Access Compliance Report

Public Rights-of-Way

Intersection ID: 9237	Main Street: REDBUD_ST	Cross Street: BOOKER_AV	Location: SE
ADA ID: 80965310C1A6	Ramp Type: PerpDiag	Initial Pass/Fail: Fail	Overall Compliance: No
Severity Score: 8.75			
Codes/Mitigation Info/Possible Solution		Field Measurements/Component Compliance

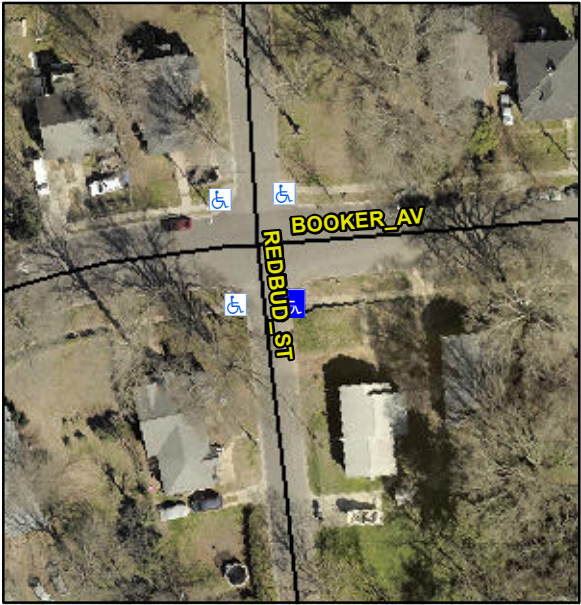
Possible Solutions:		Compliance		Description		Data	Compliance	Description	Data
	Remove & Replace Curb Ramp With Two New Directional Ramps or Equivalent.		N/A		Ramp Length (in)		59.0	Yes	Ramp Slope (%)	5.0
<p>Surveyor Notes:</p> <p>N/A</p> <p>PROW/ADA:</p> <p>Not Found, R304.5.1</p>			No		Ramp Width (in)		39.0	Yes	Ramp XSlope (%)	0.5
			N/A		Flare Type LT		N/A	N/A	Flare Type RT	N/A
			N/A		Flare Slope LT (%)		N/A	N/A	Flare Slope RT (%)	N/A
			N/A		Flare Traversable LT?		N/A	N/A	Flare Traversable RT?	N/A
			N/A		Landing Length (in)		N/A	N/A	DWS Provided?	N/A
			N/A		Landing Width (in)		N/A	N/A	DWS Contrast?	N/A
			N/A		Landing Slope (%)		N/A	N/A	DWS Length (in)	N/A
			N/A		Landing X Slope (%)		N/A	N/A	DWS Full Width?	N/A
			N/A		Landing Curb? (Y/N)		N/A	N/A	DWS Offset (in)	N/A
			N/A		Shared Landing?		N/A			
			N/A		Gutter Ponding?		N/A	N/A	Gutter Slope (%)	N/A
			N/A		Gutter Lip Ht (in)		N/A	N/A	Gutter X Slope (%)	N/A

N/A		Painted X Walk1?		No	N/A	Painted X Walk2?	No
					X Walk 1 Direction		To N		X Walk 2 Direction	To W
			N/A		X Walk 1 Width (in)		N/A	N/A	X Walk 2 Width (in)	N/A
					X Walk 1 Slope (%)		7.3		X Walk 2 Slope (%)	3.7
					X Walk 1 X Slope (%)		2.0		X Walk 2 X Slope (%)	1.6
			N/A		Ramp inside XWalk1?		N/A	N/A	Ramp inside XWalk2?	N/A
					Road Slope (%)		1.7	N/A	Clear Space?	N/A
					Road X Slope (%)		1.3	N/A	Clear Space to XWalk (in)	N/A
			N/A		Any Obstructions?		N/A	N/A	Storm Grate/Utility Hazard?	N/A
					Obstruction Type				Storm Grate/Utility Type	
								N/A		N/A
								Yes	Surface Condition? (G/P)	Good
